Request of Class II Permissive Change

Company name: Anker Innovations Limited
FCC ID: 2AOKB-T8420X
FCC Part 15 Certification

This is to request a Class II Permissive Change for FCC ID: **2AOKB-T8420X** originally granted on 01/20/2021

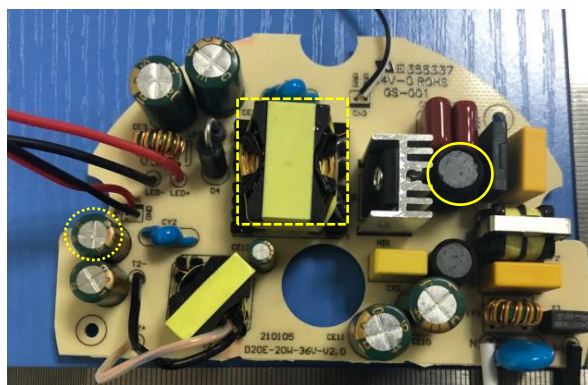
- (1) Changing the appearance.
- (2) Changing the model name to "T8422".
- (3) Changing the Product Name to "Floodlight Cam E 2K"..
- (4) Changing a few parts of the Power driver board. as follows:

No.	Name	Original	New
1	Transformer	PQ2016-6+8\0.85mH\28W-36V600 mA.	PQ2016-0.85mH-01\PQ2016-6+8P\ 0.85mH±5%.
2	Inductor	Φ 10*16mm \ 4.0mH.	Φ 9*12mm \ 3.0mH.
3	Capacitor	680uF \ 20%\16V\ Φ 8*11.5mm\ -55~105°C.	680uF\ ± 20%\10V\LESR\ Φ 8*12mm\105°C.

4	PCB	HySX25W36VV08-D-01-20210202 ,Size:L90*W87*T1.6mm.	D20E-20W-36V-V2.0\210105,Size:L 106.7*W67.5*T1.6mm.
---	-----	--	--
